SHOPS AT MERIDIAN RANCH CONVENIENCE STORE

LOT 2, THE SHOPS FIL. NO. 1A AT MERIDIAN RANCH

Grading & Erosion Control Plans

El Paso County, Colorado

**SITE GRADING AND
 EROSION CONTROL PLAN**

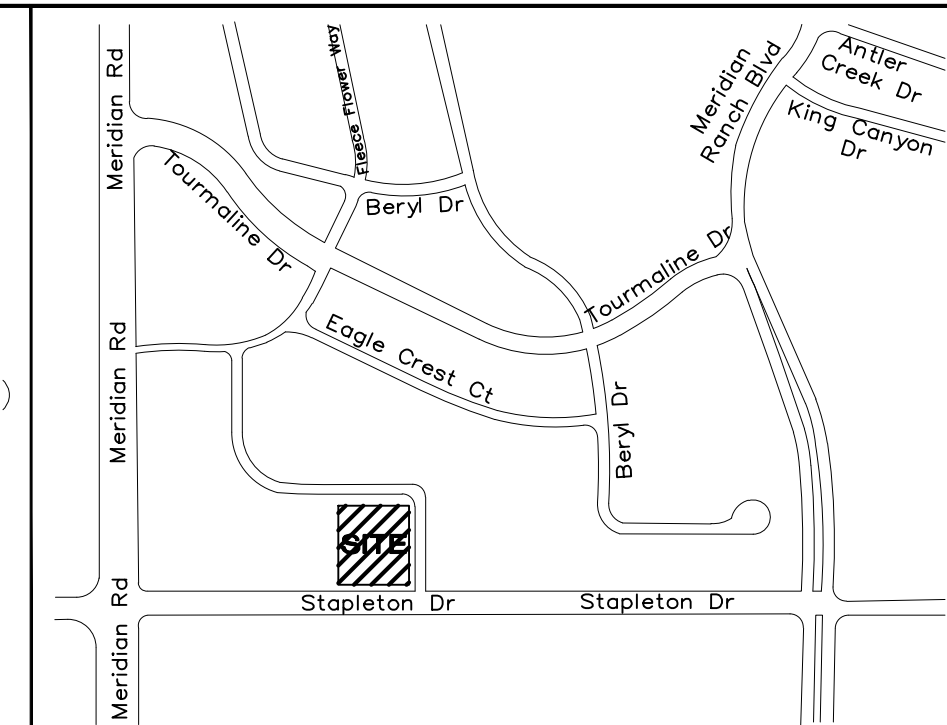
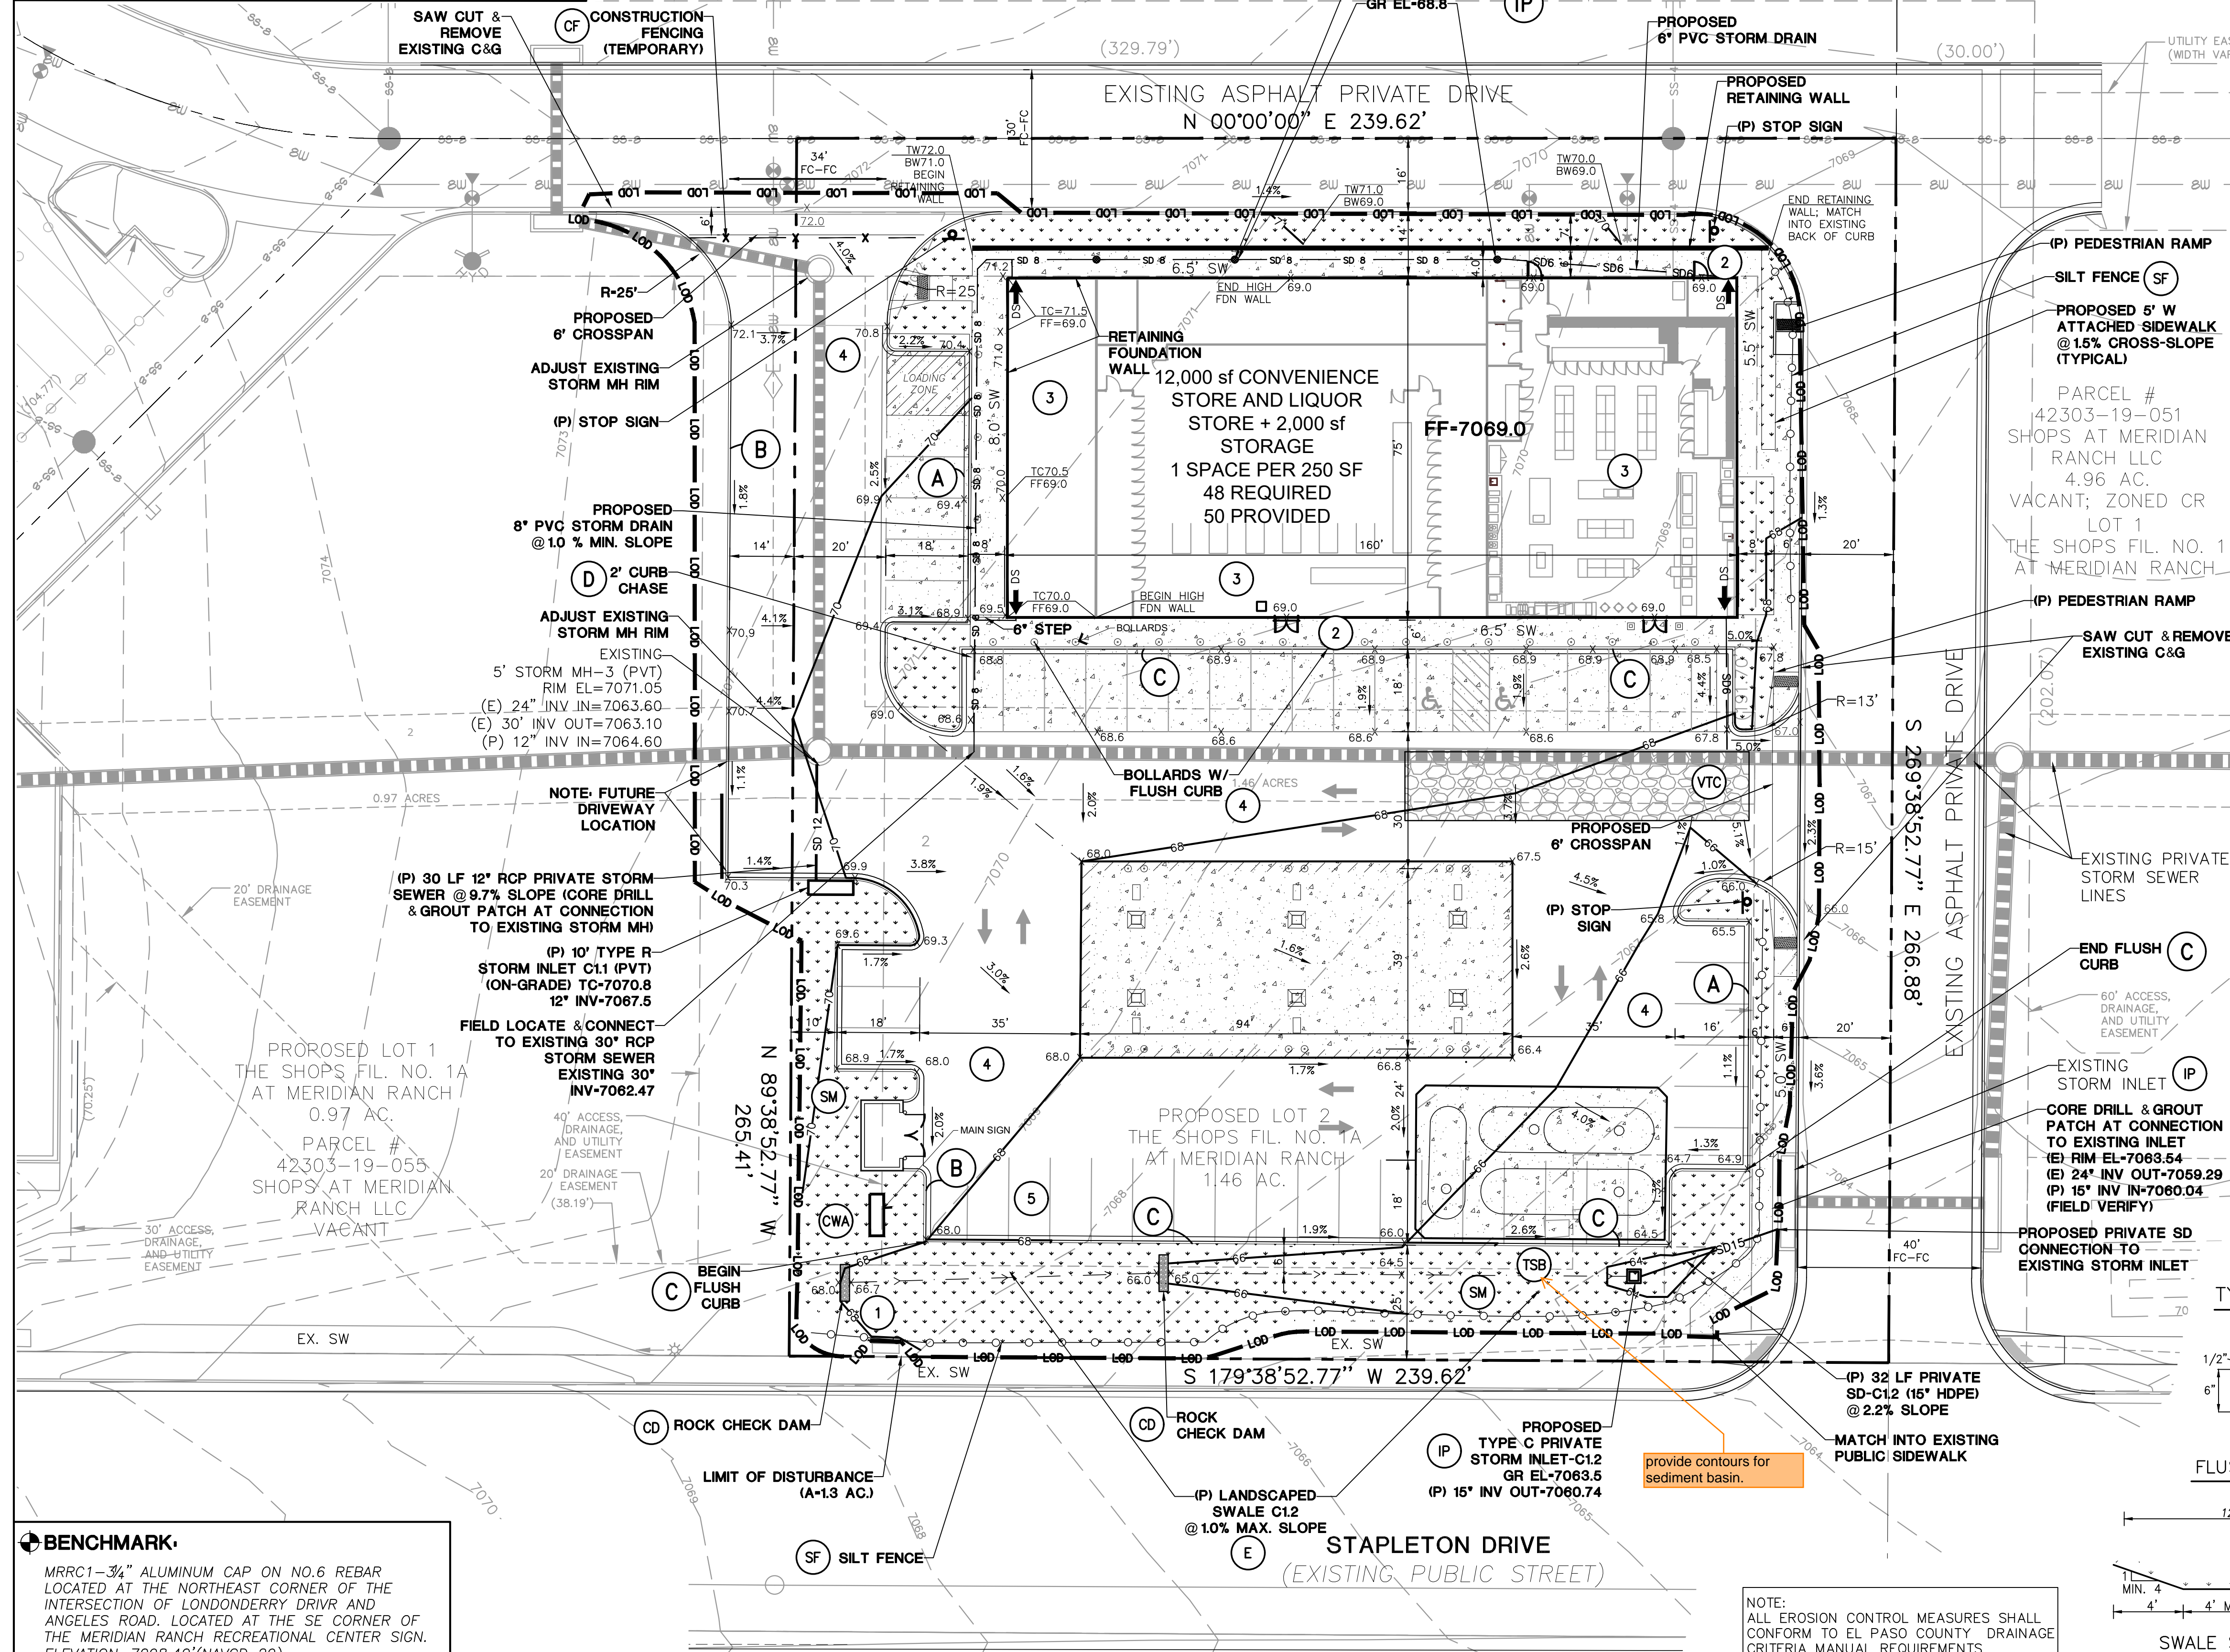
- SWMP NOTE:**
 1. EXISTING VEGETATION CONSISTS OF NATIVE GRASSES
- CONTROL MEASURE PHASING:**
INITIAL CONTROL MEASURES: Add TSB
- VTC
 - SILT FENCE ALONG DOWNSTREAM EDGE OF GRADING LIMITS
- INTERIM CONTROL MEASURES:**
- INLET PROTECTION
 - TEMPORARY SEED & MULCH
- FINAL CONTROL MEASURES:**
- SEEDING & MULCHING
